Tres Laurels 16-inch Water Main Extension Project
Solicitation Number: CO-00607-SR
Job No.: 22-1102

ADDENDUM 1
October 31, 2022

SAWS JOB NO. **W3**

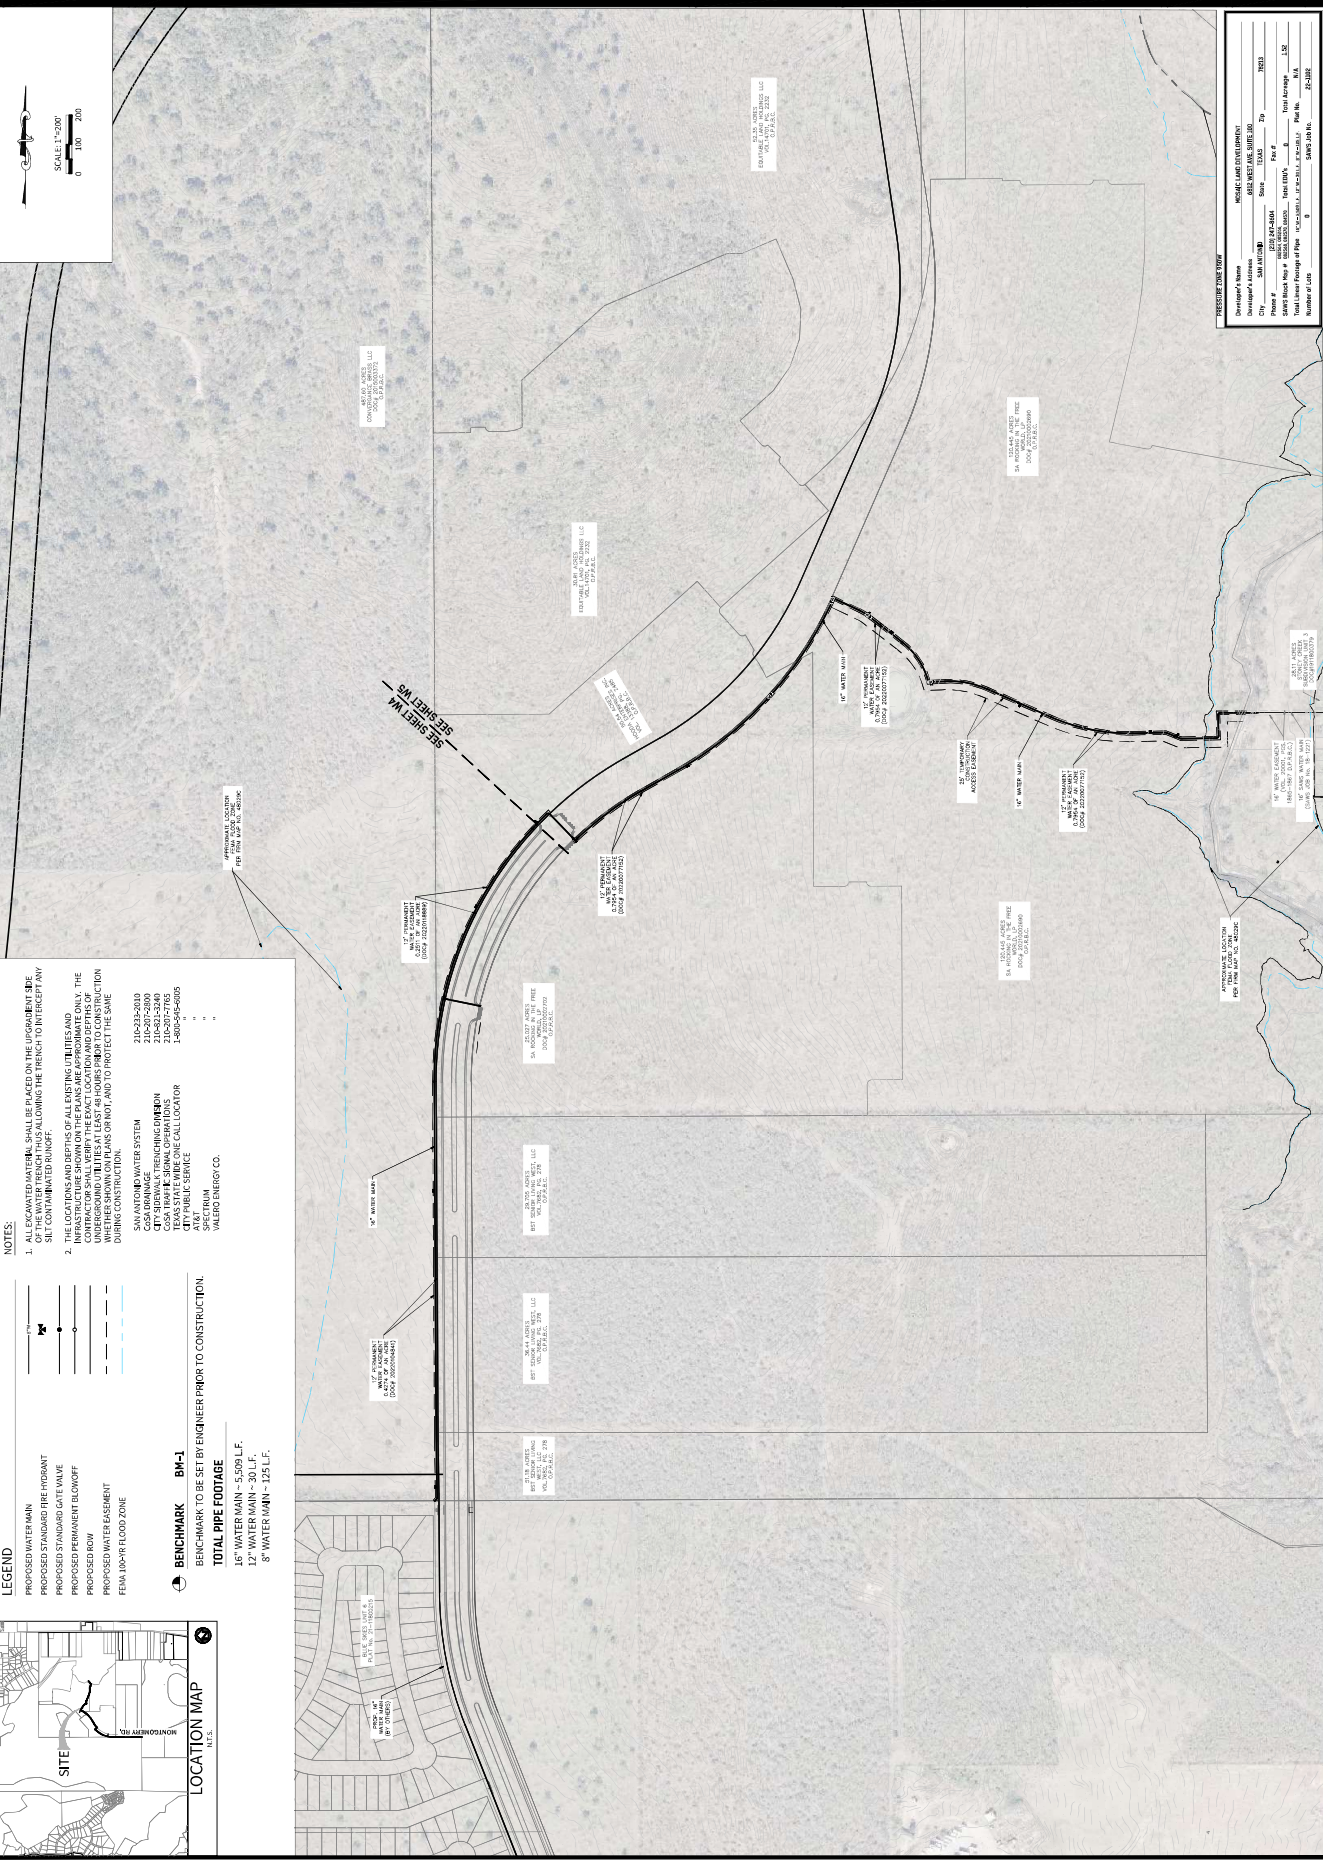
4. Question: Besides the 12' permanent easement, will there be a temporary construction easement and how wide will it be?

1. Remove sheets W3 through W5 and replace with the revised versions attached to this Addendum. A 25' temporary construction easement has been added.
2. Sheet E1, SWPPP has been inserted at the end of the construction plans.

Response: See #1, Changes to the Plans, with revised sheets W3 through W5, showing a temporary construction access easement within the future Tres Laurels development. Where the water main abuts Montgomery Road, existing ROW shall be used for construction access.
